SUBJECT: EDWIN I. HATCH NUCLEAR PLANT, UNITS 1 AND 2 – STAFF
ASSESSMENT OF RESPONSE TO 10 CFR 50.54(f) INFORMATION
REQUEST – FLOOD-CAUSING MECHANISM REEVALUATION
(CAC NOS. MF3868 AND MF3869)

STAFF ASSESSMENT BY THE OFFICE OF NUCLEAR REACTOR REGULATION
RELATED TO FLOODING HAZARD REEVALUATION REPORT
NEAR-TERM TASK FORCE RECOMMENDATION 2.1
EDWIN I. HATCH NUCLEAR PLANT, UNITS 1 AND 2
DOCKET NOS. 50-321 AND 50-366

Figure 3.2-1: Site layout and topography (from FHRR, SNC 2014a)

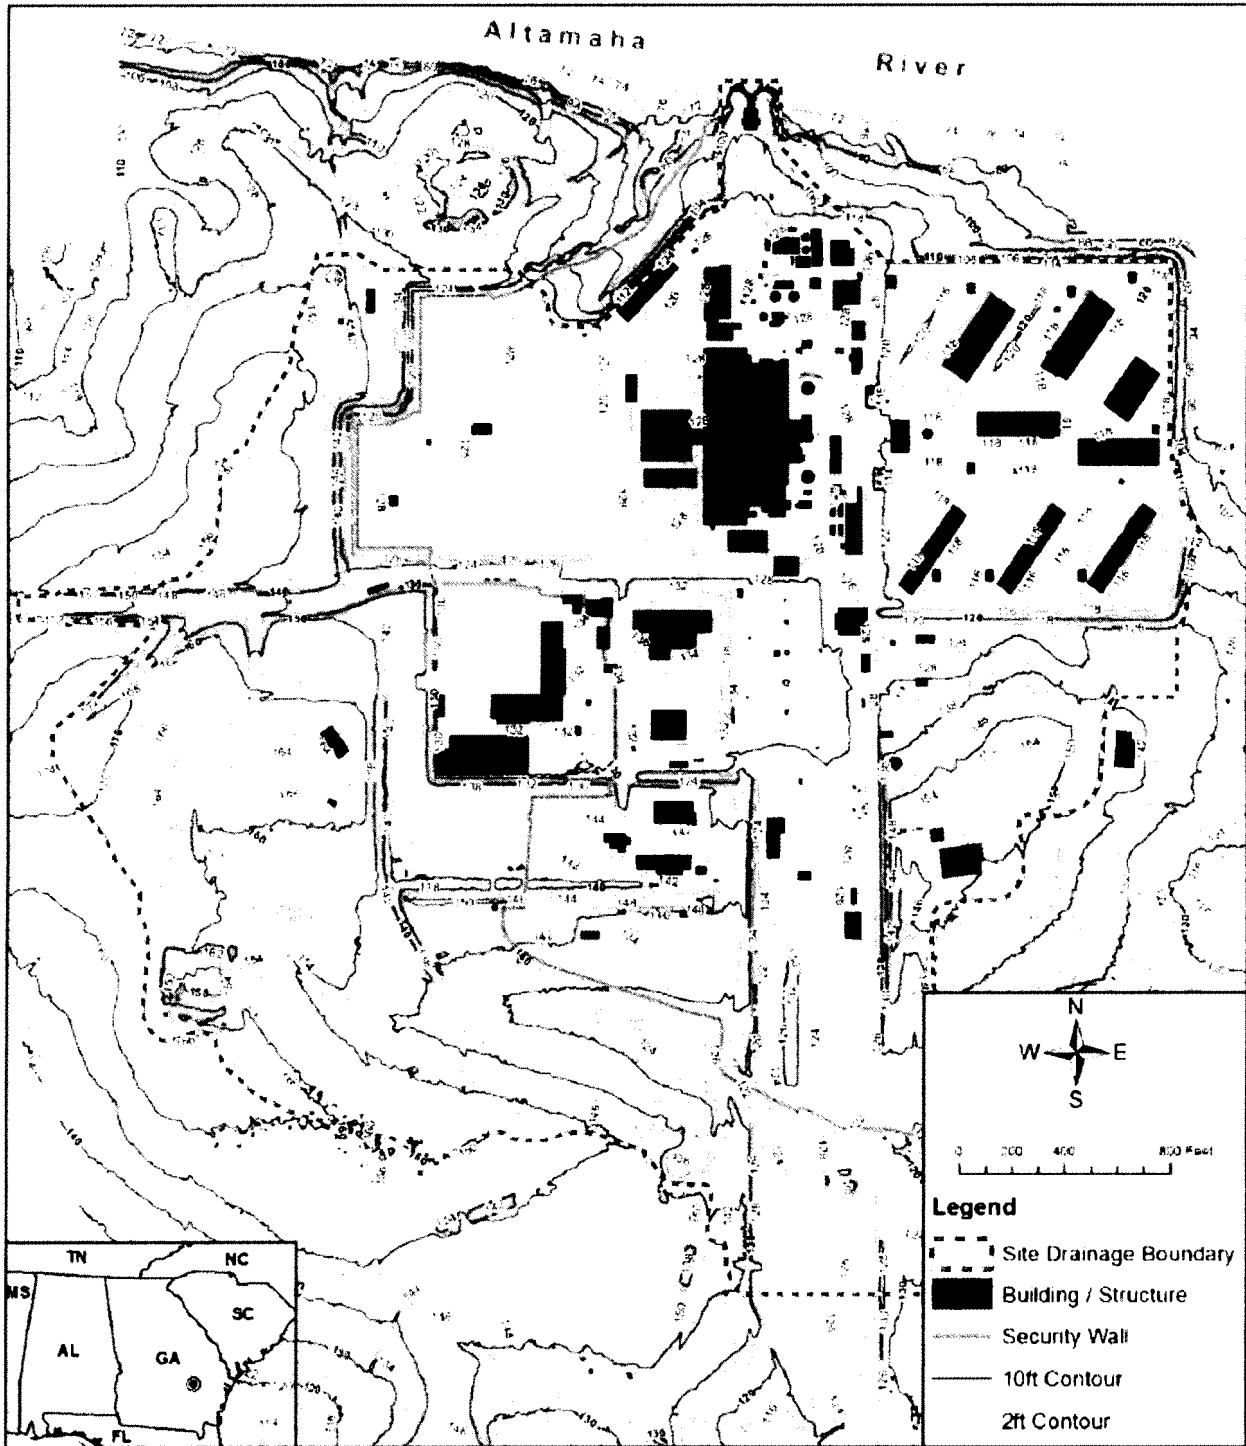
In Section 5 of its FHRR, the licensee stated that its LIP reevaluation was conducted in accordance with NUREG/CR-7046 (NRC, 2011e) and the analysis is based on a precipitation input equivalent to the 1-hour, 1-mi² (2.6 km²) probable maximum precipitation (PMP) event at the HNP site, as determined from Hydrometeorological Report (HMR) 52 National Oceanic and Atmospheric Administration (NOAA) (NOAA, 1982). The licensee used the two-dimensional hydrodynamic computer model FLO-2D Build 2009.06 (FLO-2D, 2009) to simulate runoff resulting from this PMP event. As discussed in the audit report (NRC, 2016b), the FLO-2D model simulates the full catchment basin draining to the site and consists of 122,089 grid elements of size 10-ft (3.0 m) by 10-ft (3.0 m), a resolution which the licensee considered adequate for providing appropriate topographic detail of the site. Topographic data were available through a combination of light detection and ranging (LiDAR), survey, and as-built information. LiDAR data, originally provided in the NAVD88 datum, were converted to the NGVD29, using a conversion that NGVD29 elevations are 0.8 ft (0.24 m) higher than NAVD88 elevations (NRC, 2016b). Figure 3.2-1 shows the site layout and topography, as well as the model domain, security barriers, and buildings.

Aerial photography was used to estimate the Manning's roughness coefficients (n-values). Based on the category of land cover developed from aerial photography, Manning's n-values were assigned. The licensee also conducted a sensitivity analysis to assess the impact of Manning's n-values on the maximum water surface elevation (WSE). The analysis compared the effect of Manning's n-values at the high and low ends of the recommended ranges, and found that the differences in WSE were 0.1 ft (0.03 m) or less (NRC, 2016b). The staff found the licensee's range of values reasonable.

The concrete blocks, or vehicle barrier system (VBS), were modeled as 3.5 ft (1.07 m) tall levee features within the model. If water exceeds that elevation, flow will occur over the VBS surface according to the broad crested weir equation with a weir coefficient of 2.85. Buildings, tanks, and cooling towers within the site were modeled as flow obstructions by assigning an approximate top/roof elevation based on LiDAR data. Area reduction factor and width reduction factor values were assigned to accurately model flow conditions around the dry storage casks within the southern independent spent fuel storage installation pad (NRC, 2016b). The 1-hour, 1-mi² (2.6 km²) PMP event was developed using HMR 52, with sub-hourly rainfall amounts estimated using figures 36 to 38 (NOAA, 1982). The resulting PMP values are provided in Table 3.2-1. The licensee arranged incremental PMP values following a front-loaded temporal distribution, with the most intense rainfall occurring at the beginning of the event. The FLO-2D model used the rainfall distribution input, including these incremental rainfall depths, with a total simulation time of 24 hours and rainfall distributed evenly across the site. NRC staff compared the licensee's PMP values with HMR 52 and confirmed the licensee's reported PMP values. The staff found the licensee's PMP values were reasonable.

Figure 3.3-1: Streamflow and watershed locations (from FHRR, SNC 2014a)

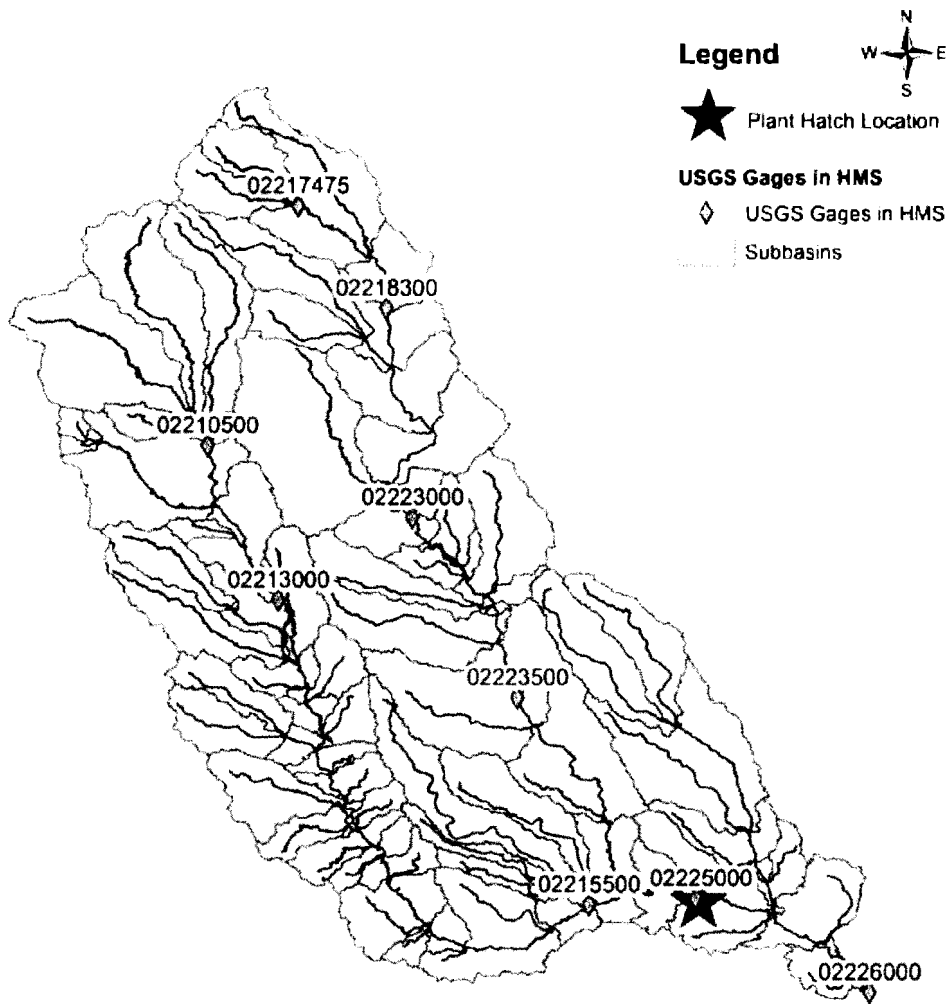
Using a digital elevation model (DEM) of the Altamaha River watershed from USGS, the licensee delineated subbasin boundaries for a total of 76 subbasins, ranging in size from 2 to 717 mi² (0.6 to 218.5 km²). These subbasins were delineated for each USGS stream gauge, tributary confluence, and critical dam within the watershed. Figure 3.3-1 shows the locations of USGS stream gauges and the subbasins.

Figure 3.3-2: Temporal distributions of the critical PMP event (from FHRR, SNC 2014a)

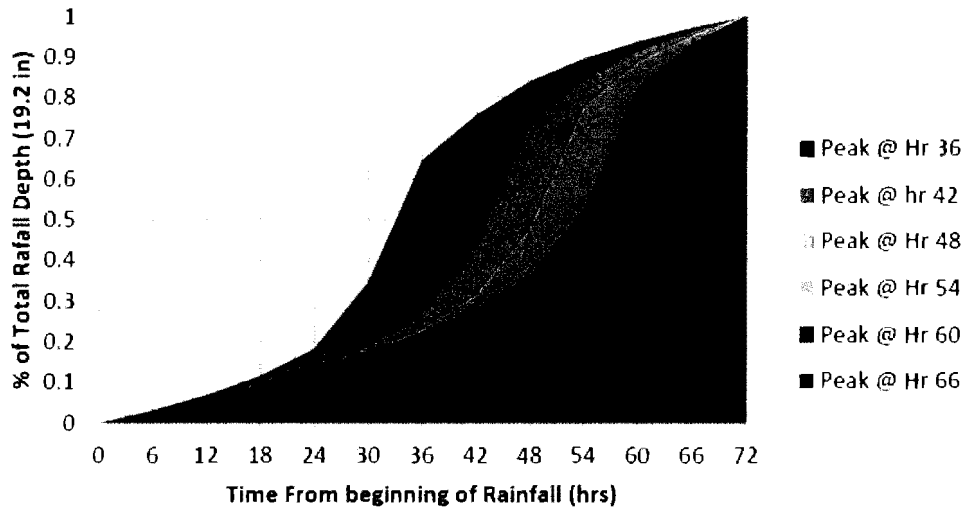
Watershed boundary. The one-hour to six-hour rainfall temporal distribution ratio, preferred storm orientation, and depth-area-duration data were determined from HMR 51 and 52 using the storm center location. The HMR 52 software determined the optimal storm center, orientation, and size combination to maximize watershed rainfall depth and produce the basin-average hydrograph for the probable maximum storm. This approach determined the all-season 72-h PMP value to be 19.20 inches (48.77 cm). To account for long lag times, the 40 percent PMP was added as an antecedent event, followed by a five-day dry period and subsequent full PMP. Six different full PMP temporal rainfall distributions were evaluated to determine the maximum runoff potential, with various combinations of 40 percent PMP distributions also evaluated. The resulting critical storm was a 40 percent PMP preceding a 5-day dry period and full PMP with peak precipitation at 234 hours; the associated peak PMF discharge was found to be 899,636 ft³/s (25,472.8 m³/s) at the HNP site. Figure 3.3-2 shows the various temporal distributions that were evaluated for the PMP event.

The licensee selected a 5-day intermediate dry period rather than a shorter period (e.g., three-day) as recommended by NUREG/CR-7046. The licensee provided a sensitivity analysis suggesting fairly low sensitivity to dry period duration (SNC 2015 and 2016). The NRC staff reviewed the sensitivity analysis and determined that the assumption of a 5-day intermediate dry period is reasonable. Additional details regarding this assumption and the sensitivity analyses are provided in the dam failure flood hazard section of this staff assessment (i.e., Section 3.4).

Figure 3.4-1: Hatch watershed and location of major dams (from FHRR, SNC 2014a)

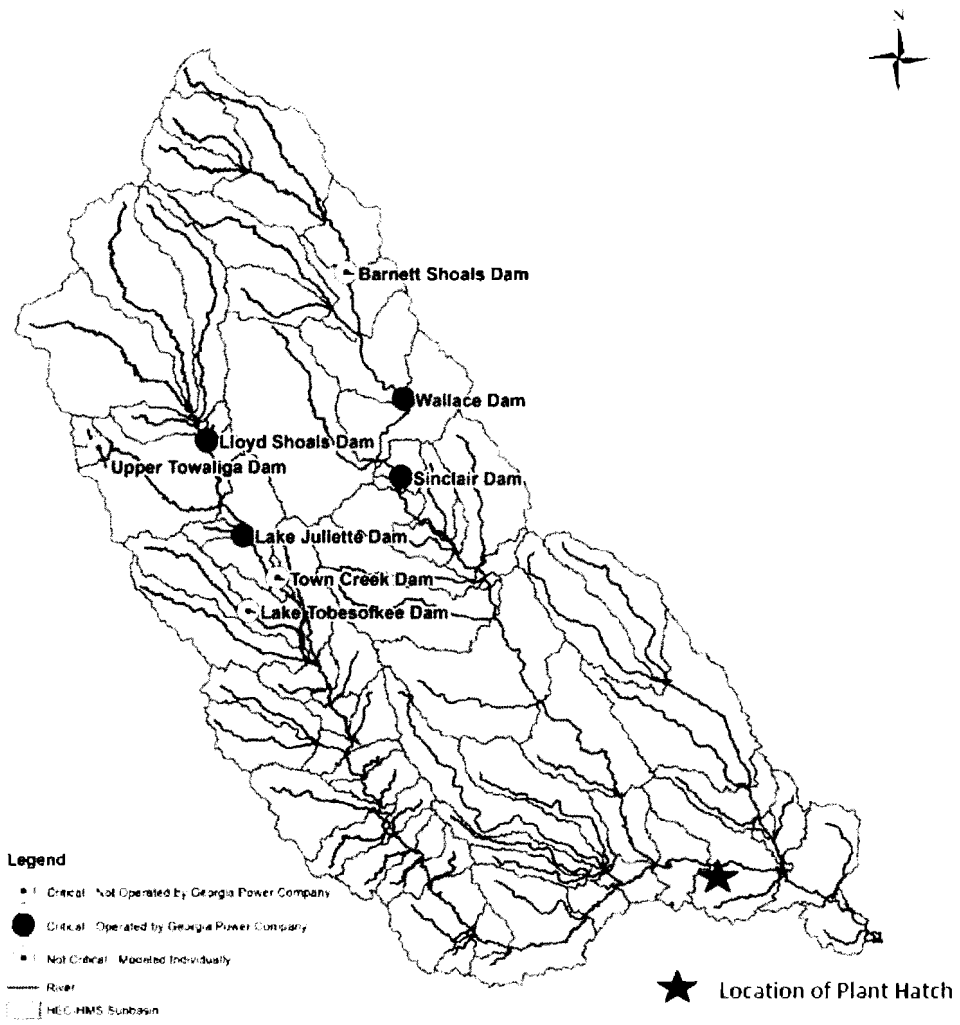
The licensee used the calibrated HEC-HMS model developed for PMF evaluation to simulate the hydrological conditions of the dam failure scenarios. Based on methodology outlined in JLD-ISG-2013-01 (NRC, 2013b), [REDACTED]. Figure 3.4-1 shows the locations of the critical dams considered in the licensee's evaluation. [REDACTED]

Staff finds the licensee's initial dam screening assessment of identifying inconsequential and potentially critical dams to be reasonable.
